STAFF REPORT WEST ALLIS PLAN COMMISSION Wednesday, March 27, 2024 Common Council Chambers 6:00 PM

- 3A. Conditional Use Permit for Tsunami Express Carwash, a proposed Car Wash with accessory drive-through service, located at 10928 W. Oklahoma Ave.
- 3B. Site, Landscaping, and Architectural Design Review for Tsunami Express Carwash, a proposed Car Wash with accessory drive-through service, located at 10928 W. Oklahoma Ave. (Tax Key No. 520-0151-001

Submitted Site Plan

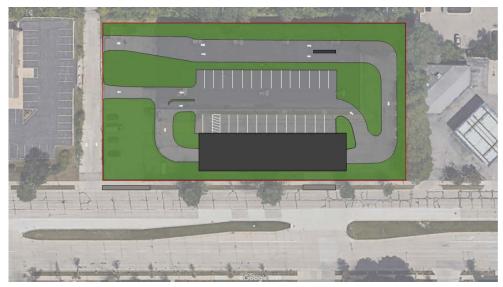
The parking lot shows a total of 31 parking stalls. For Conditional Uses the maximum number of parking stalls permitted is determined by the Conditional Use Permit. Staff recommends reduction of parking stalls to align with our <u>zoning code parking maximum</u> intentions (service uses). A refuse area with an enclosure is shown on the northwest corner of the parking lot. A vacuum pump house is also proposed in the parking lot on the southwest corner.

To conform with Design Review Guidelines staff is recommending site changes. Design Review Guidelines call for locating vehicle parking areas away from the public sidewalk while strategically buffering from the public realm. Staff recommends that the proposed car wash building is moved closer to the south property line and the parking lot & drive aisles are oriented towards the rear of the property. In this proposal the parking lot and drive-through lanes would be buffered from the public realm. Additionally, to increase traffic safety Engineering and Planning recommend removal of two curb cuts along W. Oklahoma Ave. Vehicles would instead utilize an existing access point directly west of the parcel. This would require coordination with the adjacent property owner for a cross access easement. Staff has provided this alternative to Milwaukee County and is awaiting feedback. Staff will continue to work with the applicants on any site changes.

- 1. A revised Site, Landscaping, and Architectural Plan being submitted to the Planning office to show the following: (a) Site plan showing recommended site access and building location changes per Engineering and Planning; (b) EIFS is not a permitted exterior material. Higher quality material will be needed to replace the EIFS on the building; (c) The south, street facing façade is made up primarily of masonry and split face CMU. Multiple windows align the south façade along with 4 doors. Staff recommends increased glazing along windows and doors for enhanced visual appeal; (d) Landscaping plan showing replacement of weigela and additional landscaping per City Forester recommendation; (e) incorporating vacuum pump house into main building envelope or closer in proximity to main building and away from drive entrances; (e) projected decibel level readings being shared with staff and in consideration with surrounding uses; (f) curb being installed along the west exterior perimeter of the property. Contact Steve Schaer, Manager of Planning and Zoning at 414-302-8466.

## Landscaping Plan

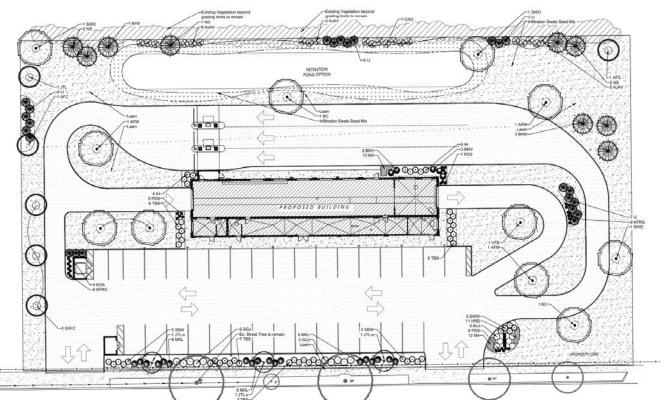
continues to the northern edge of the property with a mix of shrubs as well. An optional retention pond is also shown on the northern portion of the site. A mix of trees continues along the eastern edge of the property. In between the drive through lanes are a mix of trees and shrubs. Landscaping is shown along the building with a mix of perennials and shrubs. Additional landscaping is also shown around a proposed freestanding sign and the trash enclosure. The use of weigelia is not recommended by staff. Site plan

changes may alter the proposed landscape plan that was submitted by the applicant. Any changes to the site will require technical review and approval by staff.

## **Architectural Plan**

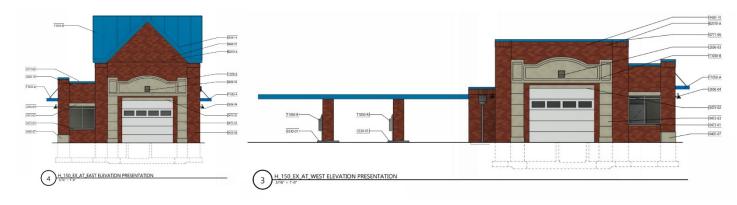
The proposed building is comprised of brick veneer, cast stone, split face CMU, and EIFS for the exterior elevations. EIFS is not a permitted exterior material (<u>Design Guidelines</u>). Higher quality material will be needed to replace the EIFS on the building. The south, street facing façade is made up primarily of masonry and split face CMU. Multiple windows align the south façade along with 4 doors. Staff recommends increased glazing along windows and doors for enhanced visual appeal. The west façade shows a mix of masonry and precast stone. A garage door is shown along with two windows. The west elevation also shows the the canopy for the payment kiosks. This consists of masonry pillars covered with an aluminum canopy. The north façade is similar to the south façade with a mix of masonry and split face CMU. The east façade appears similar to the west façade with a garage door encased by precast stone. Masonry is also utilized and is used to form a gabled roof. The pump house is shown to be constructed with split face CMU. The roof is comprised of a mix of concrete planks, steel bar joists and steel trusses colored blue.
